## CITY OF ALBUQUERQUE

INTER-OFFICE CORRESPONDENCE

SUBJECT: Revised Drainage Report of a Tract of Land Situated in the Southwest Quarter of Section 8, Township 10N., Range 4E., N.M.P.M.

DRAINAGE REPORT  
CONCERNING A TRACT OF LAND  
SITUATE IN THE SOUTHWEST QUARTER OF  
SECTION 8, TOWNSHIP 10 N., RANGE 4 E., N.M.P.M.  
for:

MENAU & WYOMING DRAINAGE ( Phoenix Ave. to Wyoming)

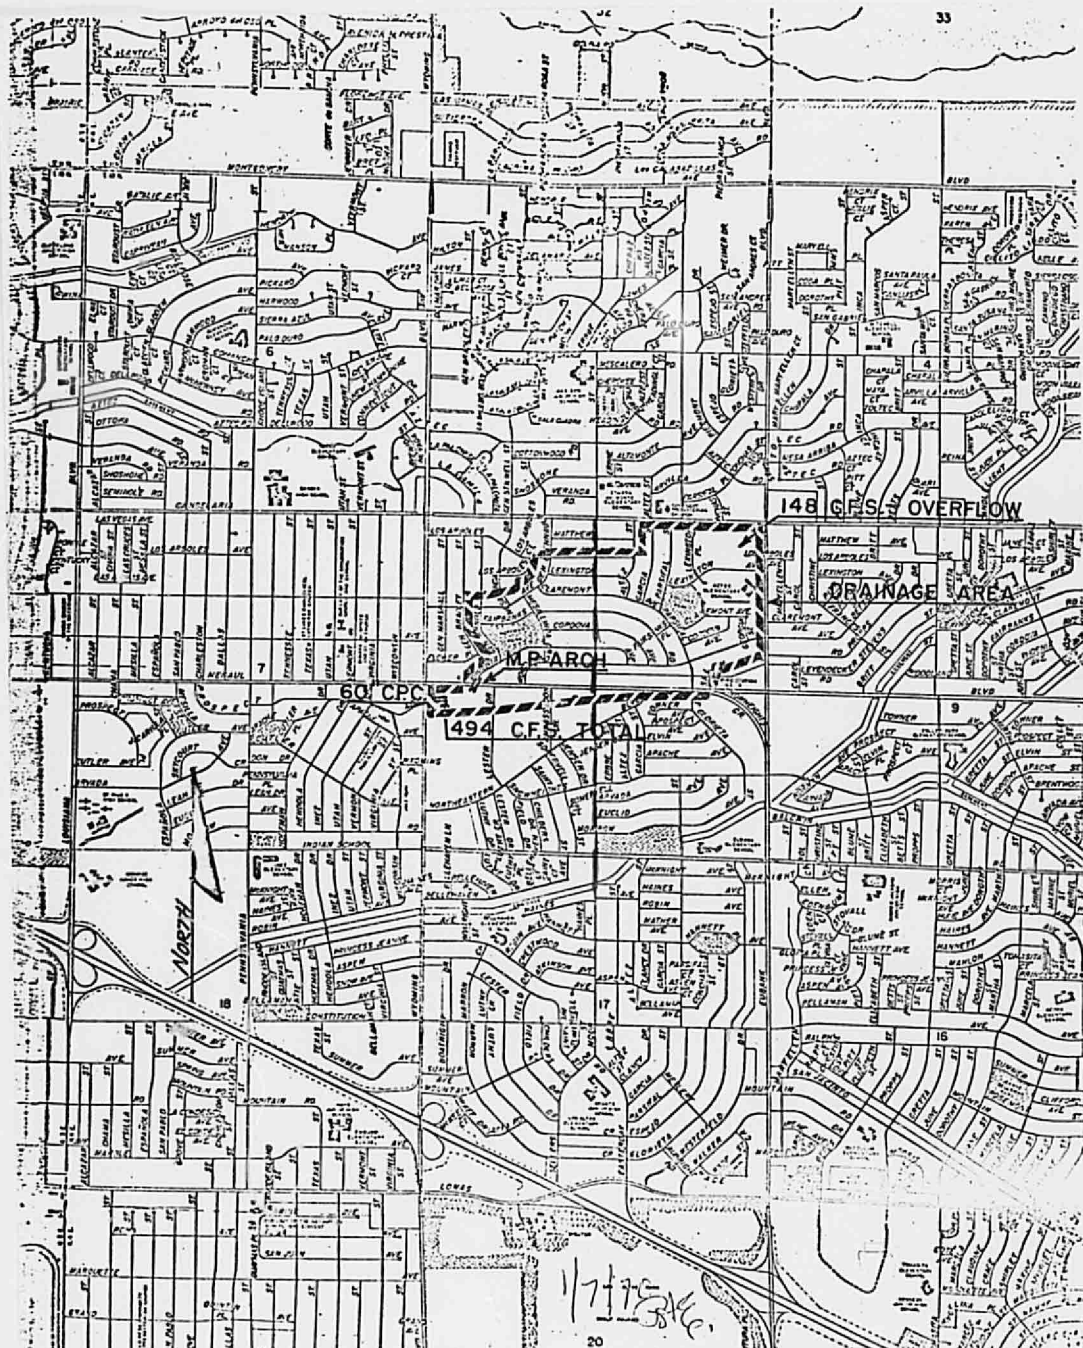
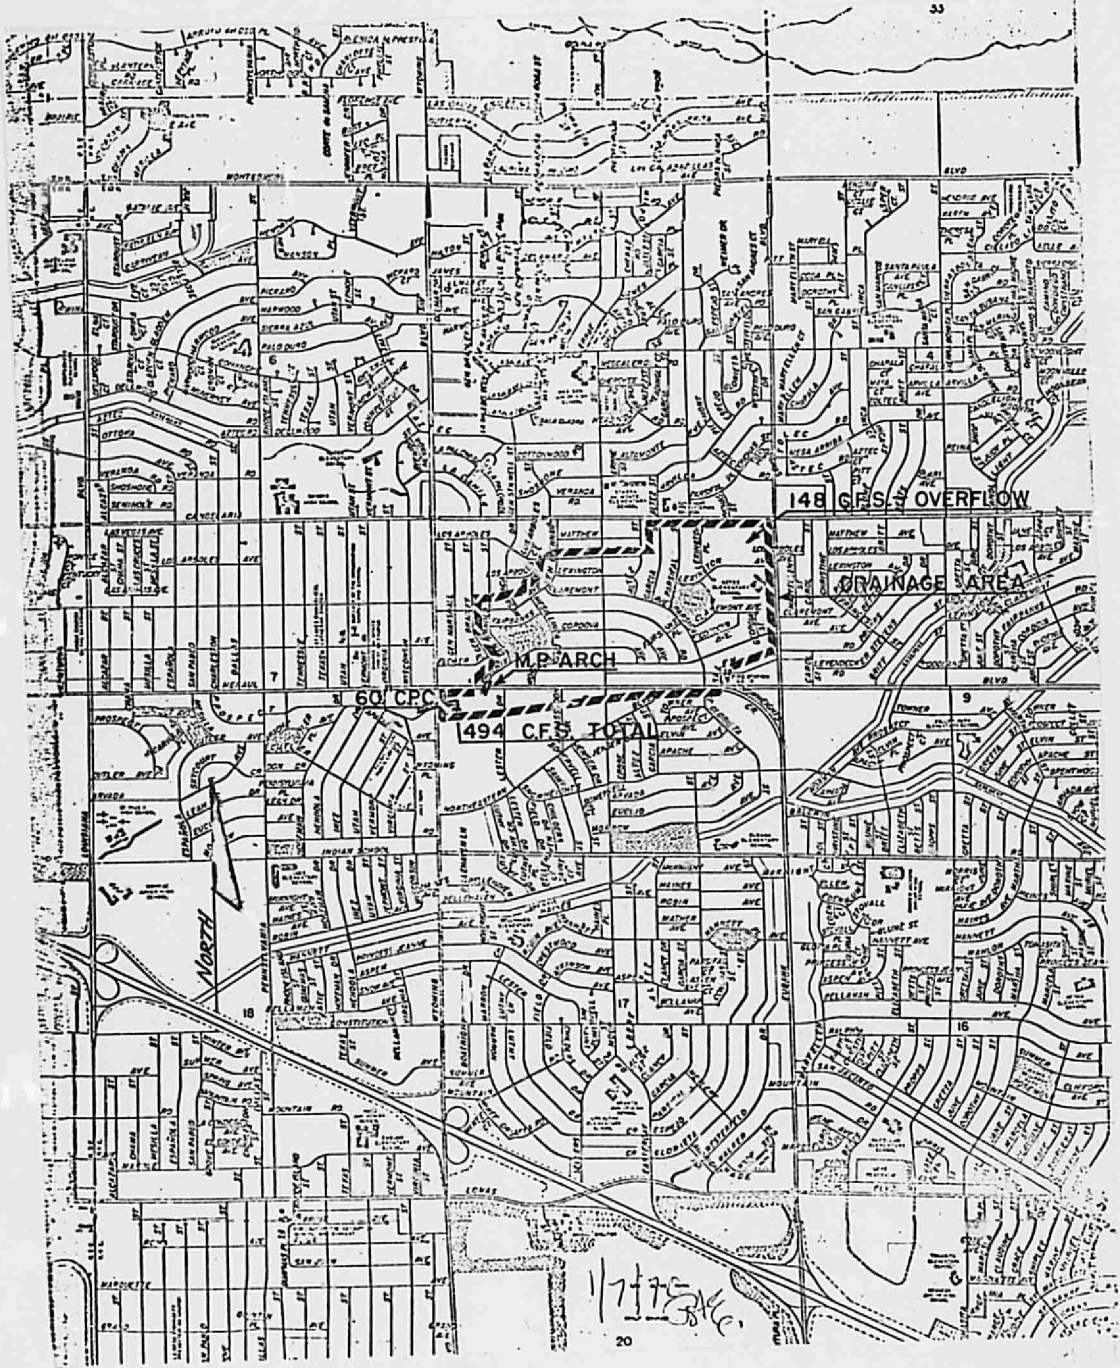
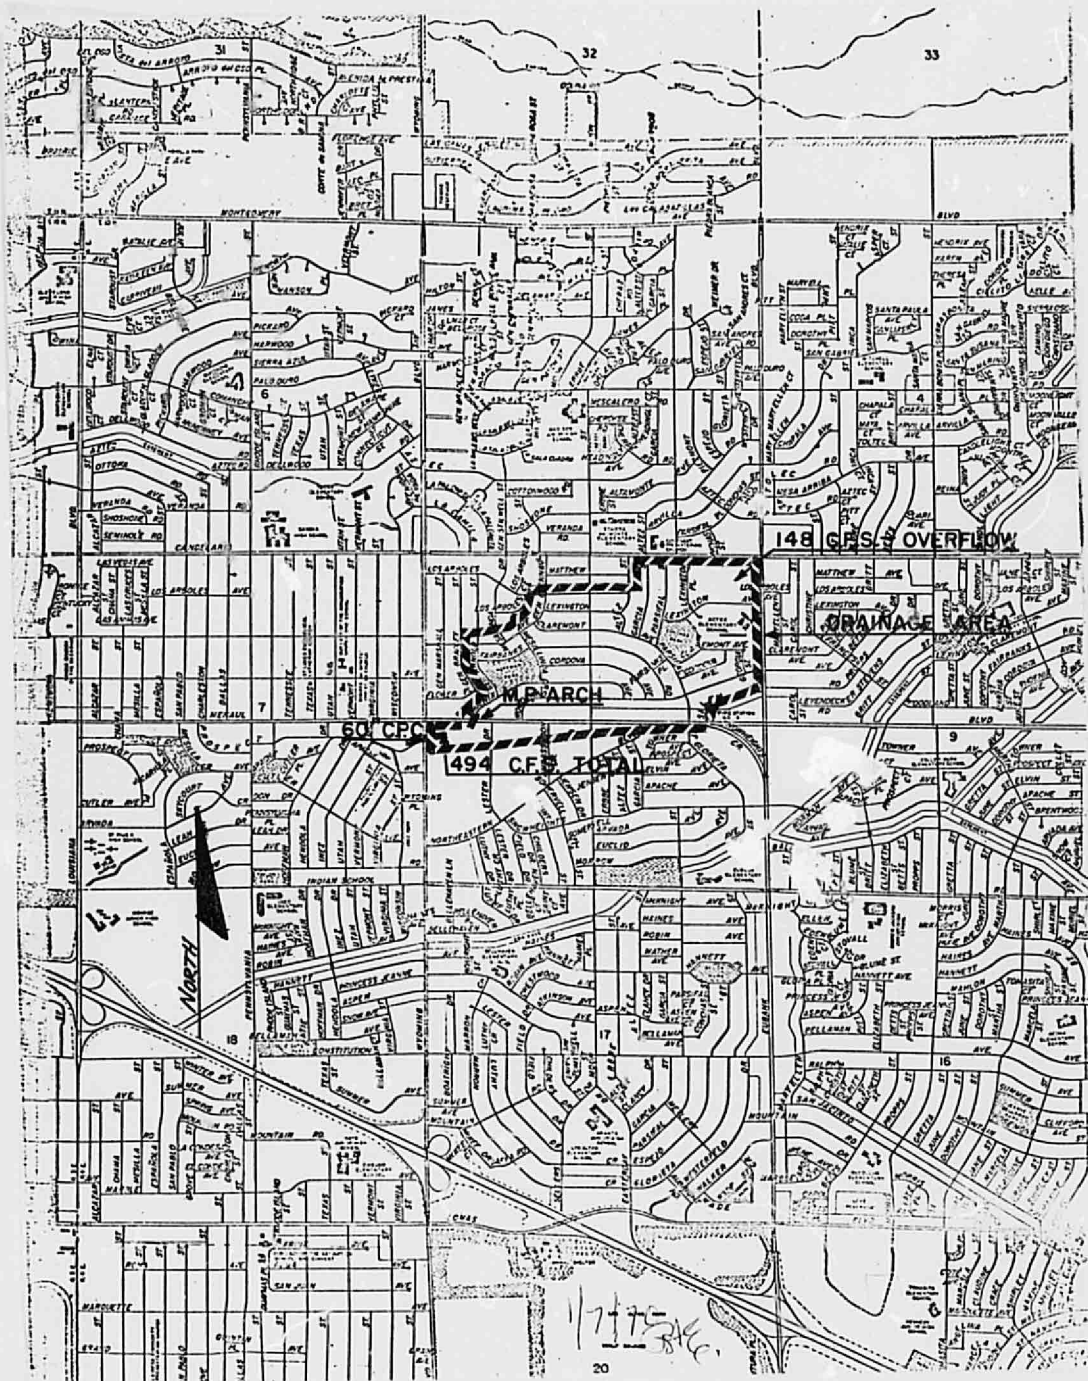
- A. The parcel of land in the study is 80% residential with front and rear private, lawn areas and considerable landscaping.
- B. The lots are not radically sloped nor are the dwellings highly elevated above existing street elevations.
- C. The conclusion drawn from the above would indicate that a runoff coefficient of .50\* would be entirely realistic and consistent with good engineering practices.

\* The original report used .65

The culvert capacity of 543 c.f.s. as shown in the computations would require a 78" C.P.C. to carry the flow from the structural plate arch to the existing 60" C.P.C. at Wyoming Blvd., N.E. The 60" C.P.C. at Wyoming Blvd., N.E. will carry 360 c.f.s. leaving an excess of 494 c.f.s. - 360 c.f.s. or 134 c.f.s. to spill out of an overflow structure onto Wyoming Blvd.

It is therefore recommended that a 78" C.P.C., approximately 680' in length be installed to carry the flow from the structural plate arch at Menaul & Phoenix to the 60" C.P.C. at Wyoming Blvd. It is also recommended, when funds become available, that an interceptor trunk be extended to intercept a portion of the water in the vicinity of Moon & Menaul N.E., thereby eliminating the overflow structure in the future.

Proposed Culvert, Alignment & gradient.

Transitional structure to be designed to pickup flow from Struct. plate arch into proposed 72" C.P.C.

Transitional Overflow Structure to be designed to spill that part of the total "Q" that the existing 60" R.C.P. won't carry.

\*\* 60" C.P.C. at Wyoming crossing will carry 360 c.f.s. of the 494 c.f.s. leaving 134 c.f.s. to spill out of overflow structure onto Wyoming Blvd.

PLATE 3.

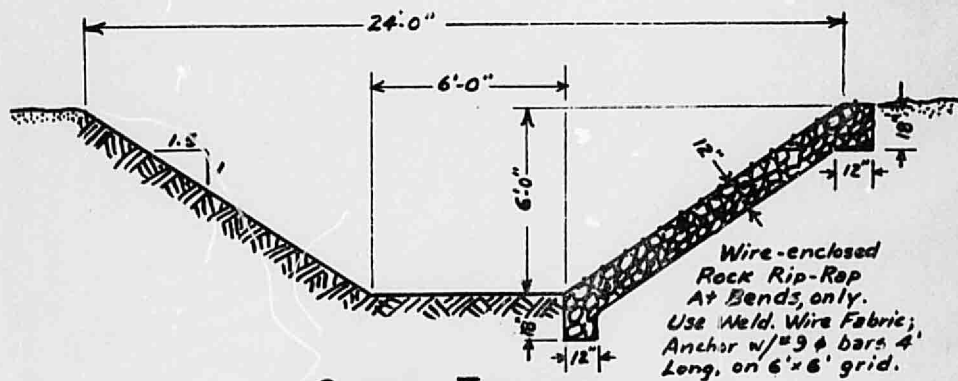
A graded earth channel could be considered, having a section such as that suggested in the detail on Plate 3. Location of the channel, to be economically feasible, would be along the North property line on Menaul Blvd. then Southerly and Westerly, beginning at a point about 70 feet East of Wyoming Blvd. as shown on Plate 2. Channel, as shown, has 6' bottom; 1.5 : 1 side-slopes and is 6' deep from floor to top of berm, or ground level.

Since 767.6 cfs greatly exceeds the maximum anticipated flow of 623.4 cfs, the channel design is adequate and will have enough "freeboard", or clearance from high water to top of channel, to take care of surges (Hydraulic Jump) caused by sharp bends in the channel. Of course, with the open channel, there would be an overflow at Wyoming Blvd. in any case, because the 60" pipe culvert beneath that street (to which the channel outlet would be connected) lacks the necessary flow-carrying capacity.
